SUBJECT: Addendum No. 4

REFERENCE: Invitation To Bid (ITB) for the FAA Non-Standard Taxiways at William P. Hobby Airport; Solicitation No. H06-HOUTXY-2023-019; Project No. 770

APPROVED BY:	DATE:
DIRECTOR HOUSTON AIRPORT SYSTEM	
PROJECT NO:	770
C.I.P. NO:	3-48-0110-044
H.A.S. NO:	N/A
SHEET NO:	EL505

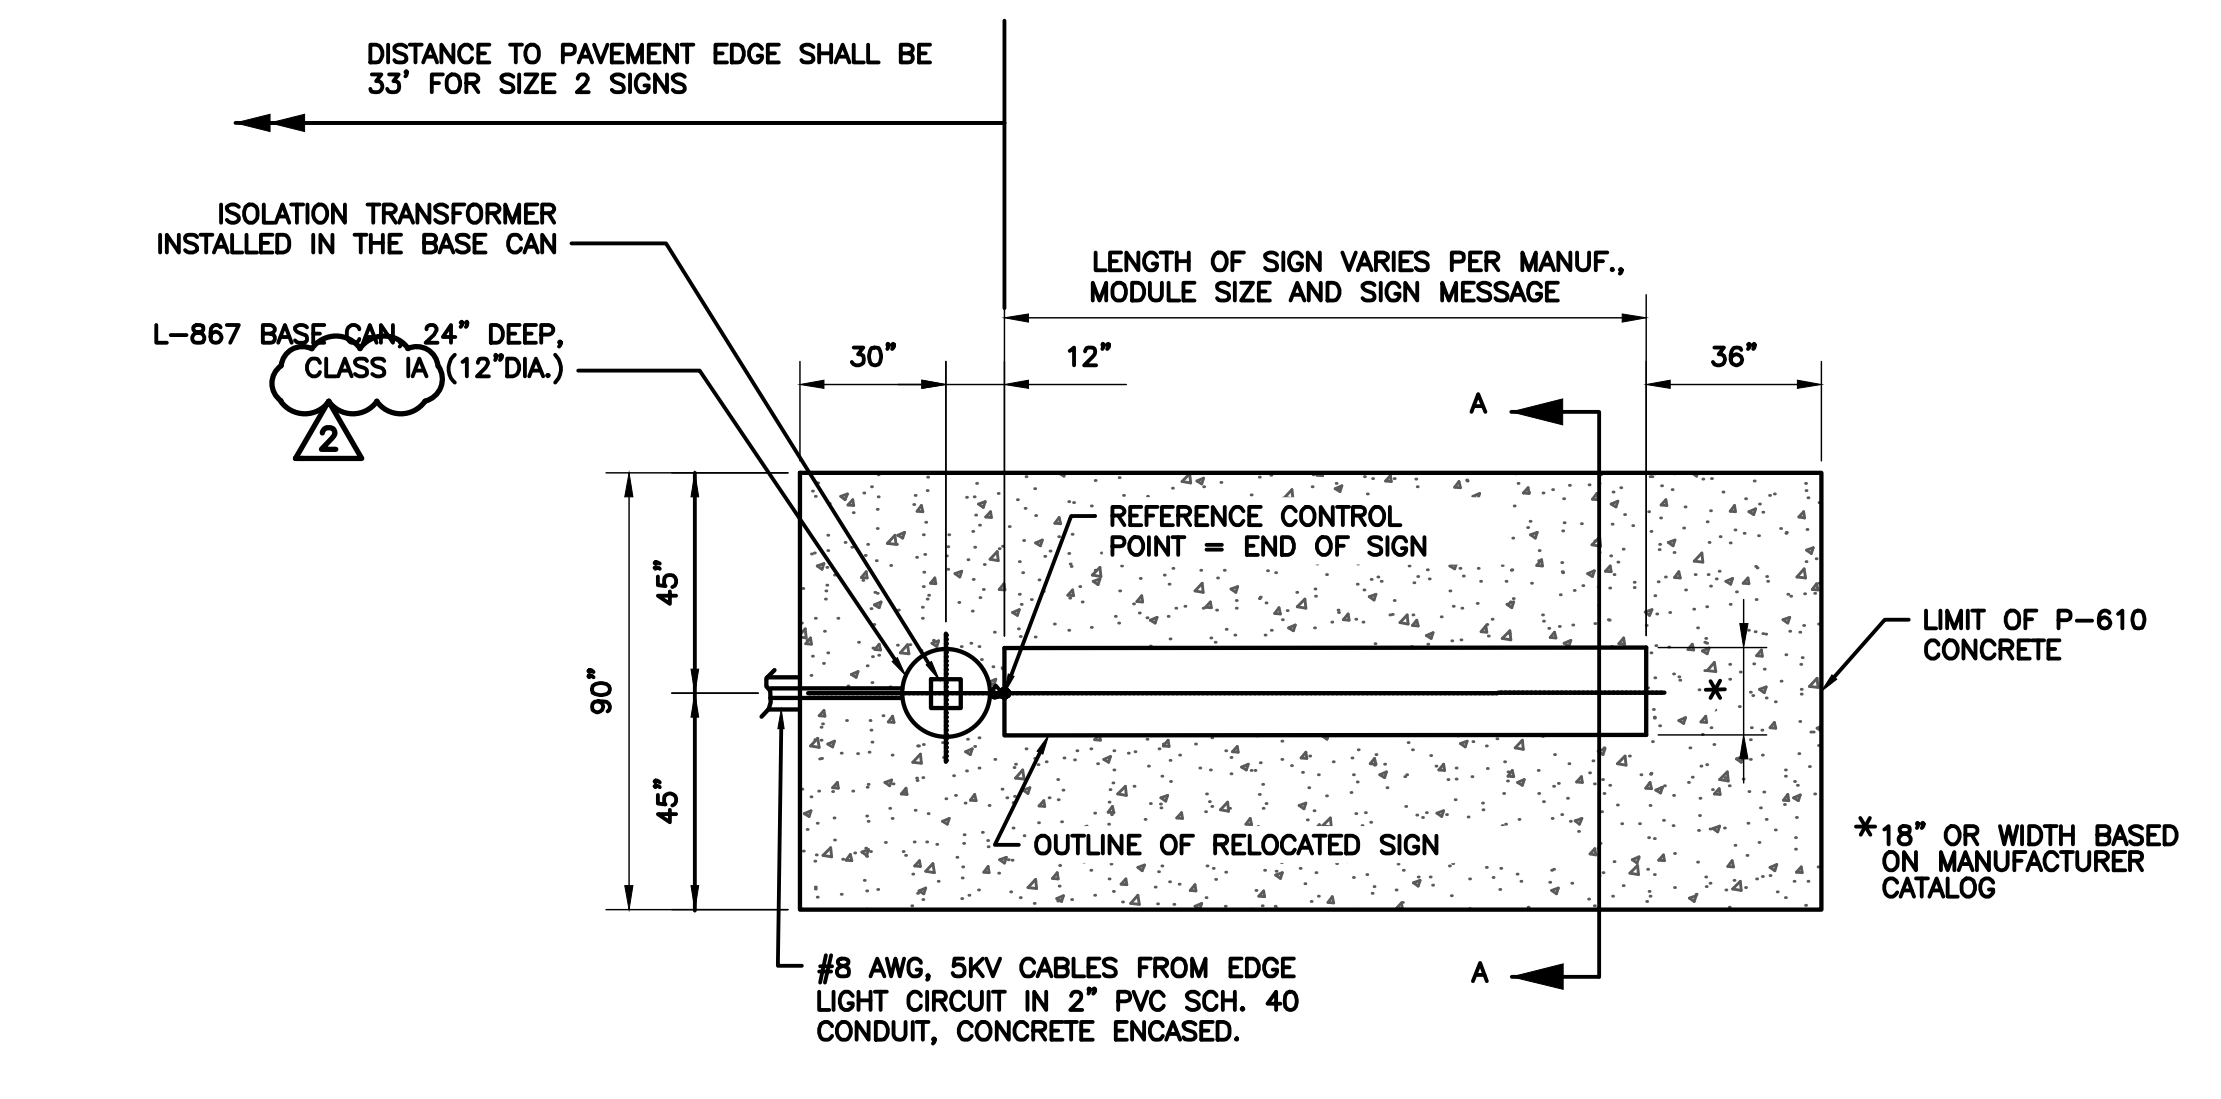
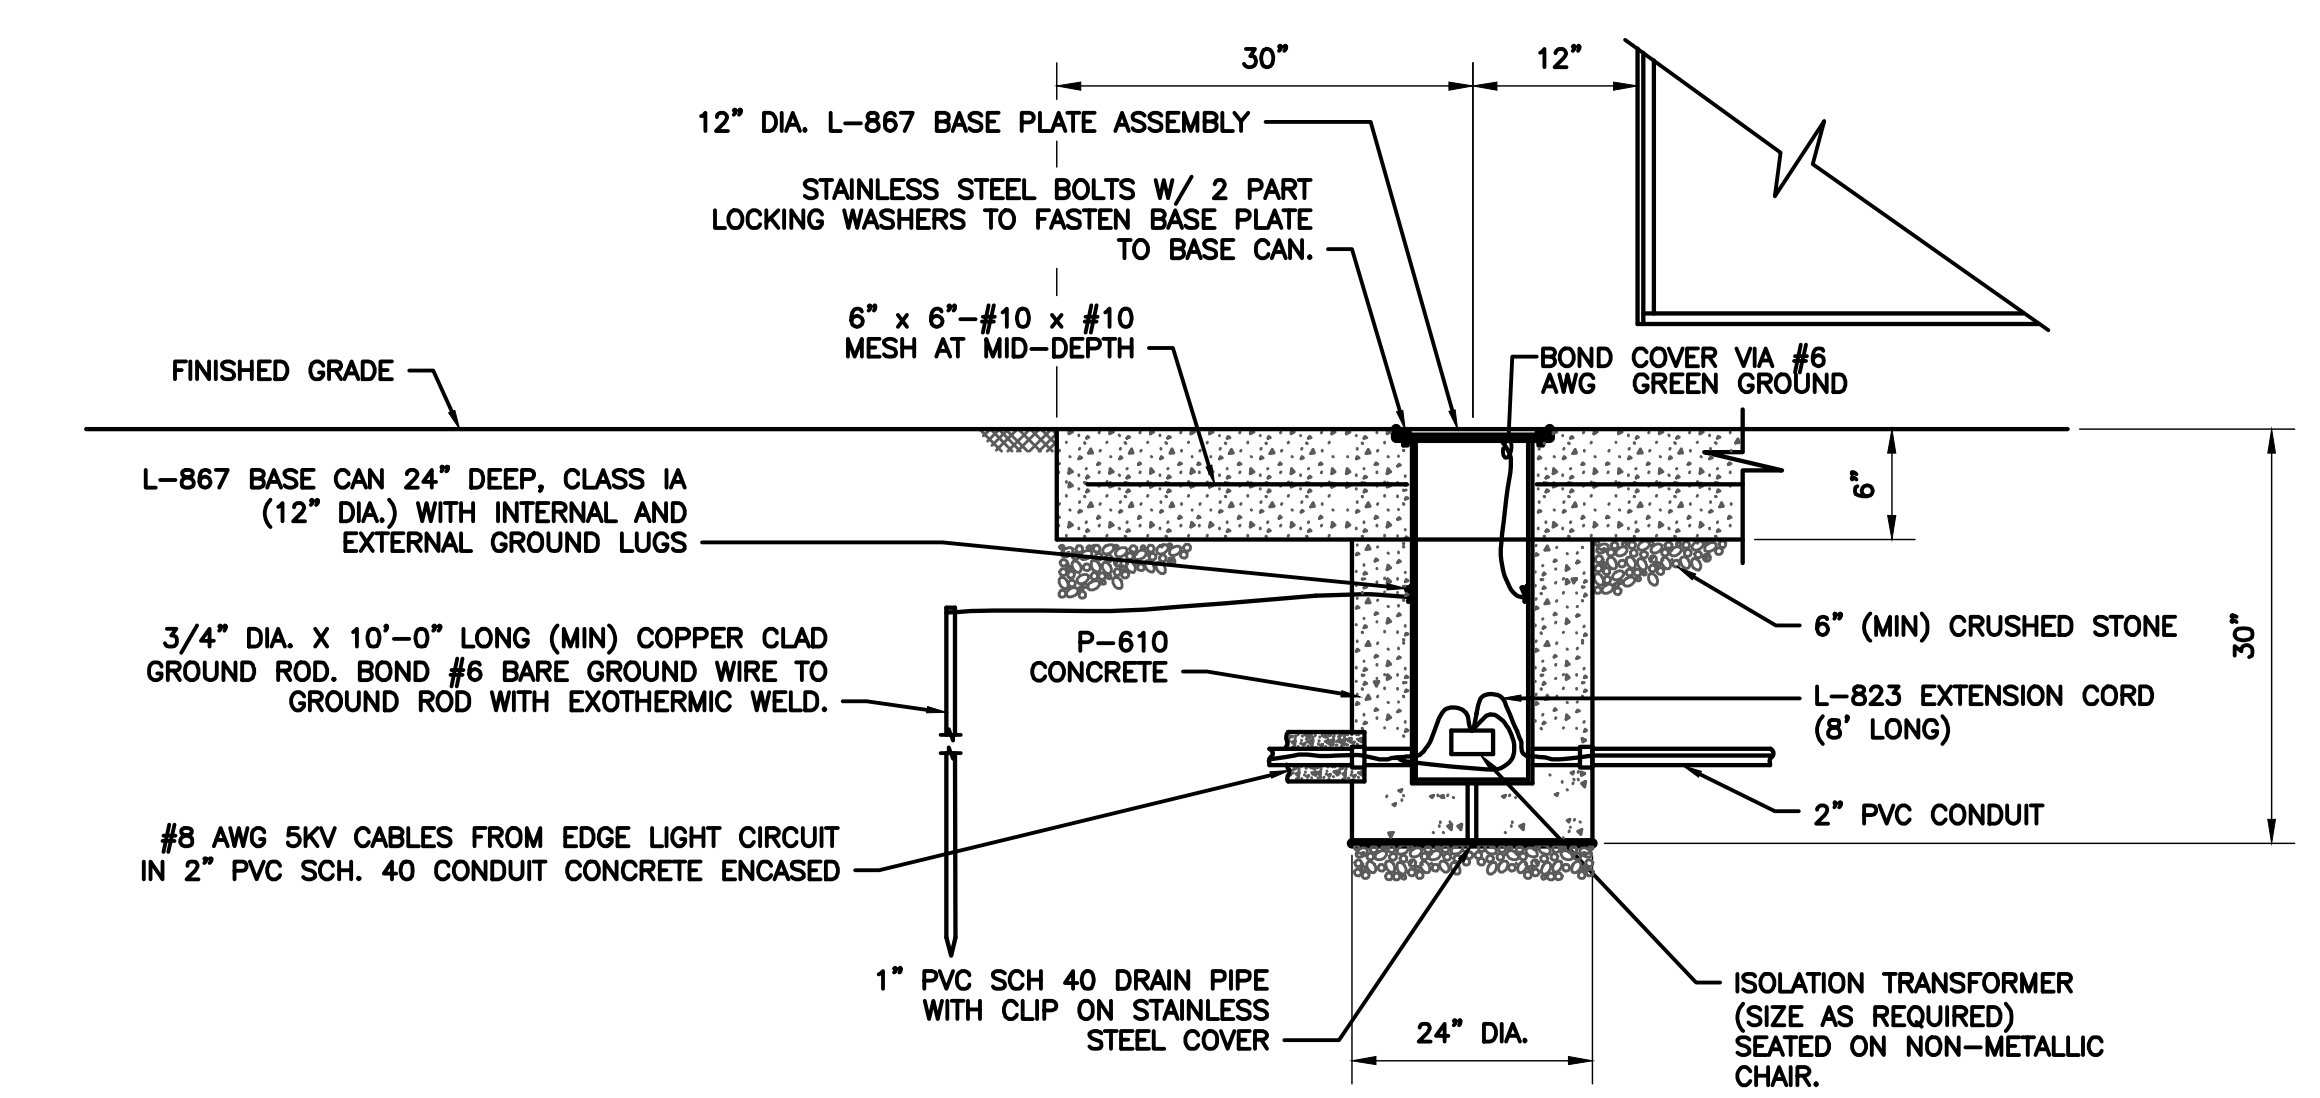
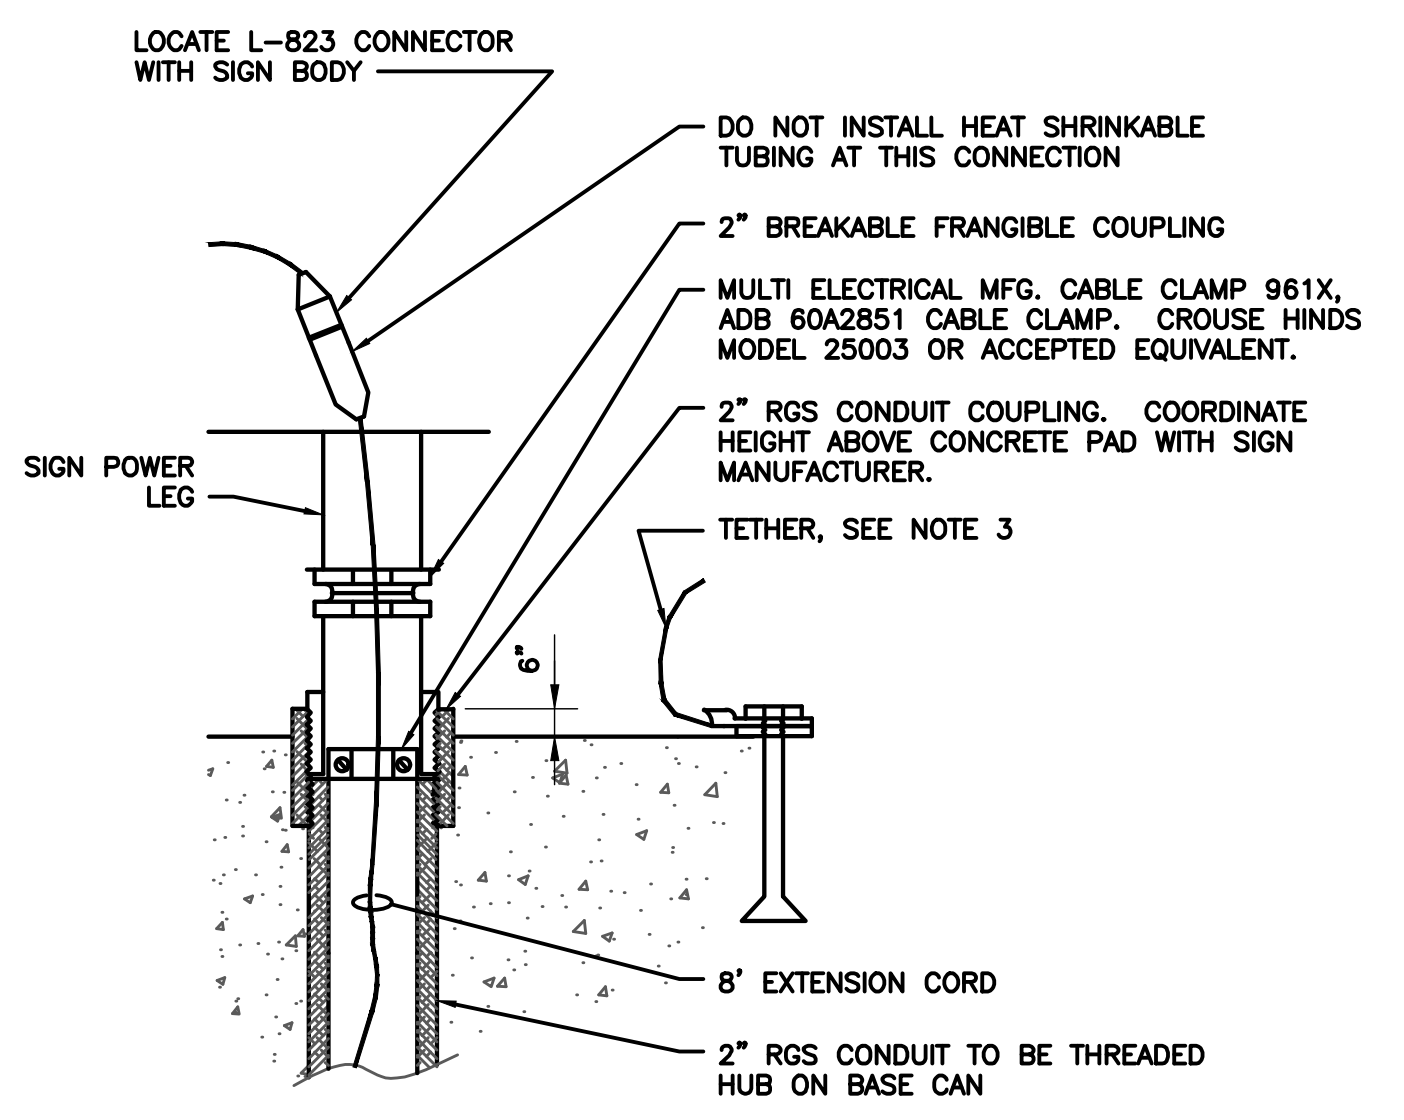
6. **Question:** Sign Detail (EL505) lists sign basecans as Class 1B. The L-125 (L-125-3, section 125-2.12) shows the basecans as Class 1A. Since Class 1B is stainless steel, and typically twice the expense of Class 1A (galvanized), does the airport want Class 1B Stainless Steel basecans?

Response: Class 1A base cans are acceptable for sign bases and revisions have been made to the plans attached. All materials to be used on the project shall be reviewed and approved by HAS and the engineer.
